MUNICIPAL CORPORATION,  
KARACHI

ORDER UNDER SCH. VI, CHP. XI, RULE 5 (1) OF  
ACT XVII OF 1933.

PLAN SHOWING THE PROPOSED BUILDING ON PLOT No 24 MM I MACHHI MIANI QUARTER SCALE 8' TO 1"

Re:- Plot No 24 M.M.1 Machhi  
Miani quarter, Karachi.

Cross SECTION OF THE BEAM

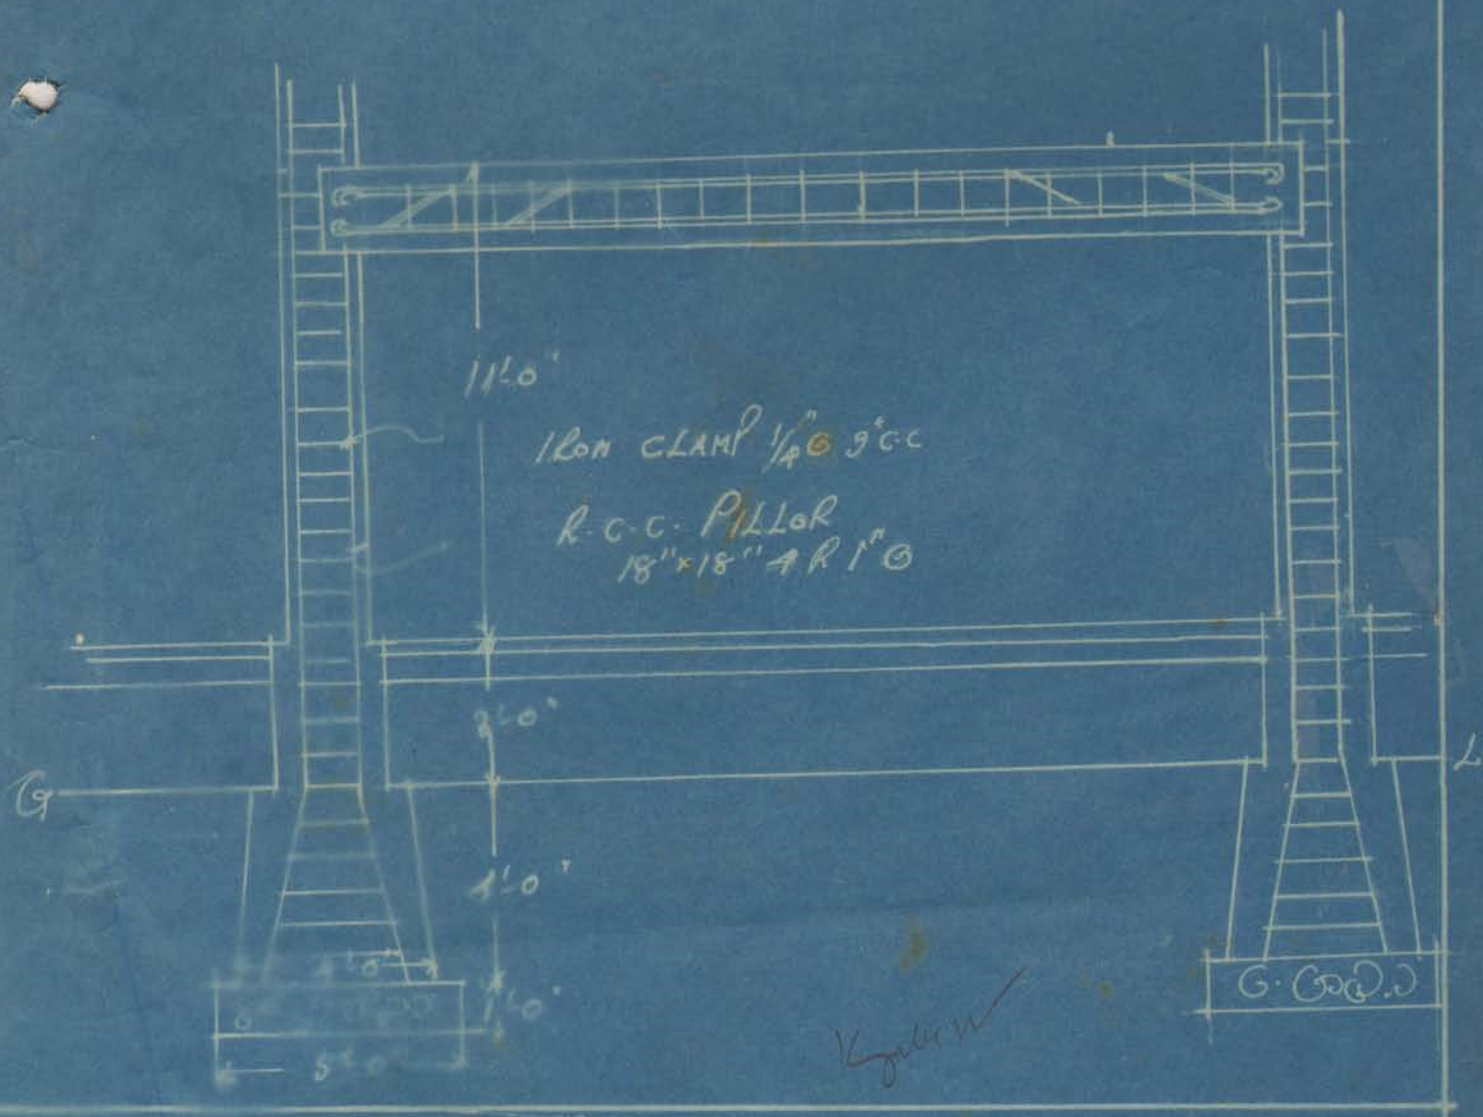
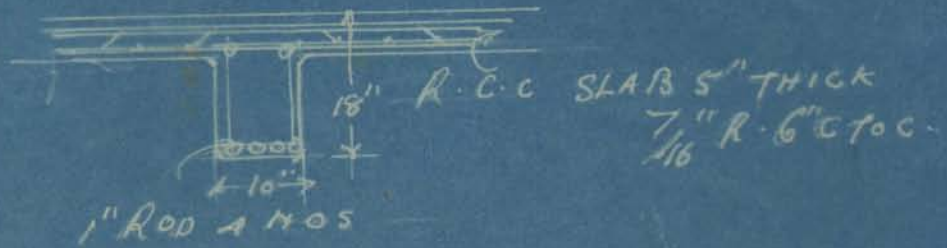
Requirements Nos. 5, 6, 7, 8,  
10 & 11 of 11/6/38  
are not complied  
with

5. The same are corrected.
6. Complied with.
7. The passage are kept 3'-6" wide and much more than those usually provided in other cases.
8. The various sizes of reinforcement have been kept as per rules. The section of the trench is given.
9. The position of the W.C. has been altered.
10. The staircase will be open to sky.
- 11 to 13. Complied with.
14. The section has been corrected.
